FOUNDATION INVESTIGATION REPORT BY -
William A. Trow & Associates Ltd. -
Proposed Crossing over Canard River,
Highway No. 18, Amherstburg, Ontario.
- W.P. 5-60 -- District No. 1 -

Foundation Investigation
Proposed Crossing over Canard River,
Highway No.18, Amherstburg, Ontario.
W.P. 5-60

FOUNDATION INVESTIGATION
PROPOSED CROSSING OVER CANARD RIVER
HIGHWAY NO.18, AMHERSTBURG, ONTARIO.
W.P. - 5 - 60

SUBJECT: W.P. 5-60-00, Bridge Site 6-120
Canard River Bridge
3.5 miles north of Amherstburg
Hwy. 18
District 1, Chatham

STABILITY ANALYSES (TOTAL STRESS)
FOR
EMBANKMENT AND APPROACH
DWG. NO. 11

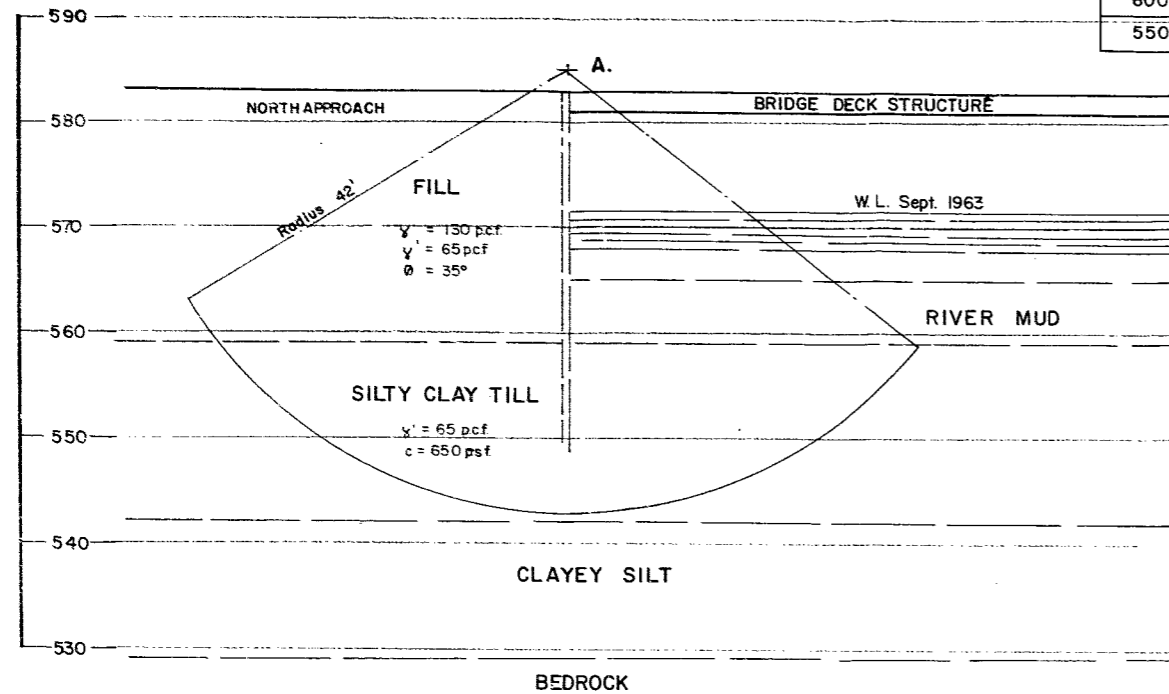
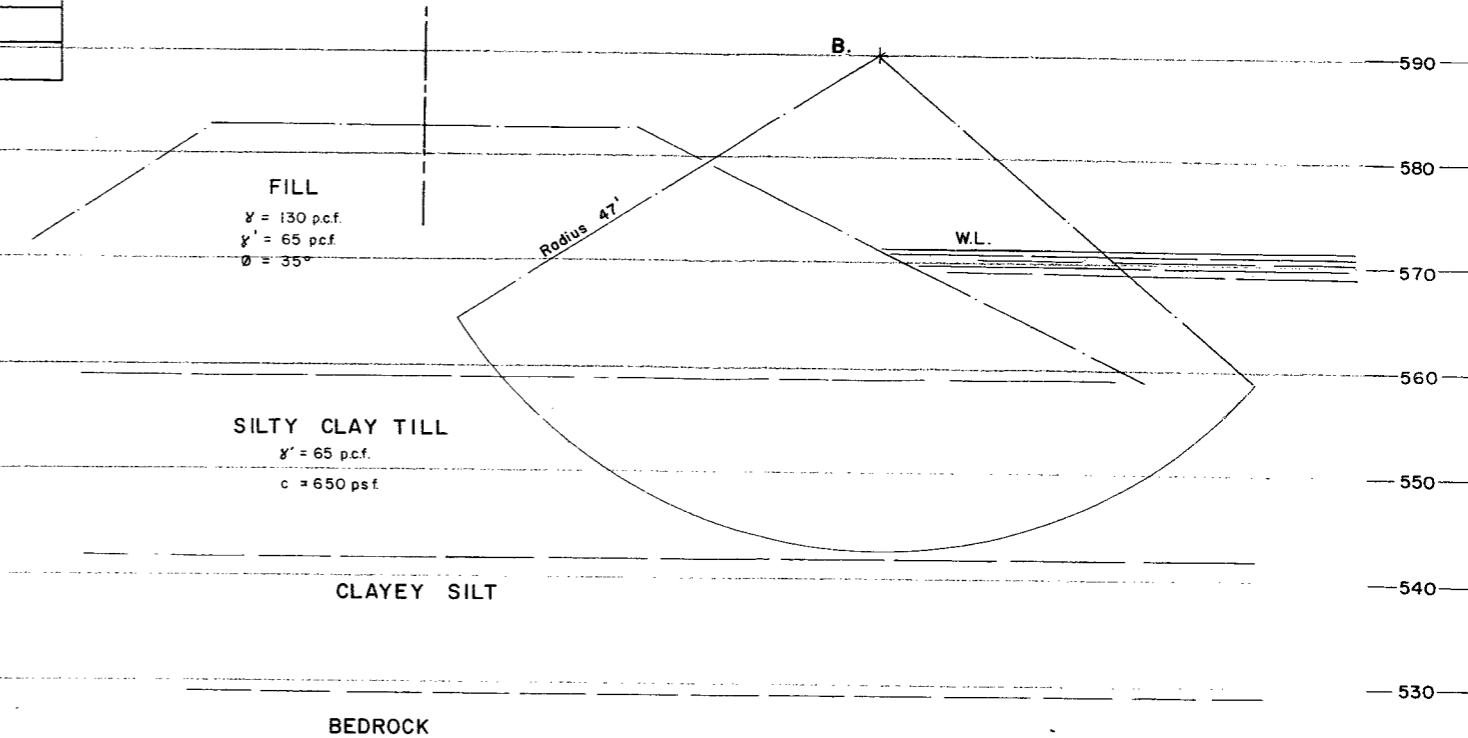
Stability analyses, in terms of total stresses, were carried out for the northern approach embankment. In the analyses, shown on Dwg. 11, both the "closed" and the "spill-through" type of abutments have been considered. Taking an average undrained shear strength of 650 p.s.f. for the clay in the vicinity of Borehole 1, the factors of safety of the embankment with respect to failure toward the south into the river were computed to be 1.22 and 1.37 respectively, for the types of abutments referred to above. Because of three dimensional resistance to failure, it is believed that the factor of safety for both embankment situations will be higher than these values.

In the analyses for the "spill through" type of abutment, a slope of 2 horizontal to 1 vertical was used for the fill placed in front of the abutment. Since the sides of the embankment will have a similar slope, the analysis is applicable for movements at right angles to the road centre line as well.

From these calculations, it is apparent that a "spill through" type of embankment will be safer. However, if this method of construction is used, provision must be made to protect the fill from erosion and in a manner that does not restrict the river flow. In view of these limiting requirements, the temporarily lower factor of safety, associated with the "closed" abutments, may appear less unacceptable.

STABILITY ANALYSIS NORTH APPENTH TO CANALS RIVER - HILL'S STRUCTURE

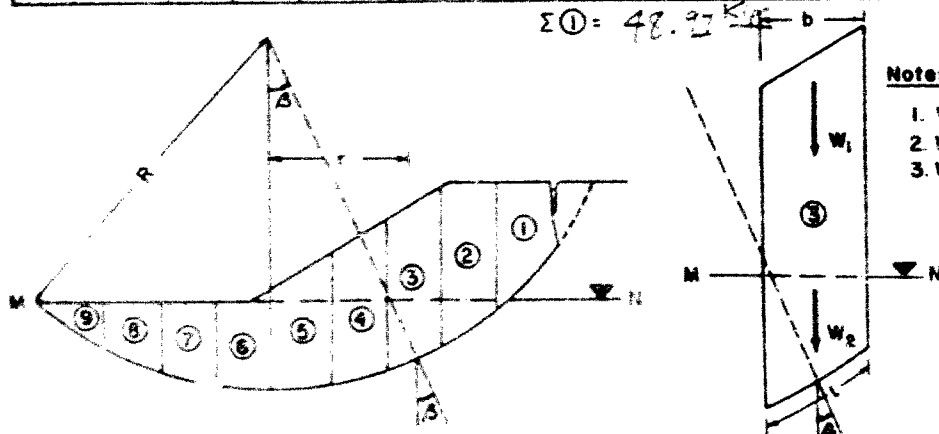
RE: STABILITY ANALYSIS
NORTH APPROACH.

<u>HWY. #18 PROFILE GRADE</u>	<u>HT OF FILL ABOVE BOTTOM OF RIVER</u>	<u>LENGTH OF BERM REQUIRED AT ELEV 573</u>
592	33'	20 feet.
589.5	30.5'	10 feet
587	28'	5 feet

ORIGINALLY A 10 FT BERM WAS GIVEN FOR APPROACH EMBANKMENT
ELEVATION 592.0. LATER IT WAS FELT THAT A SOMEWHAT HIGHER
FACTOR OF SAFETY WOULD BE DESIRABLE (APPROACHING 1.3) AND A 20 FT
BERM WAS SUGGESTED. CONSEQUENTLY FOR EL. 592.0 THE RECOMMENDATION
IS SOMEWHAT FLEXIBLE.
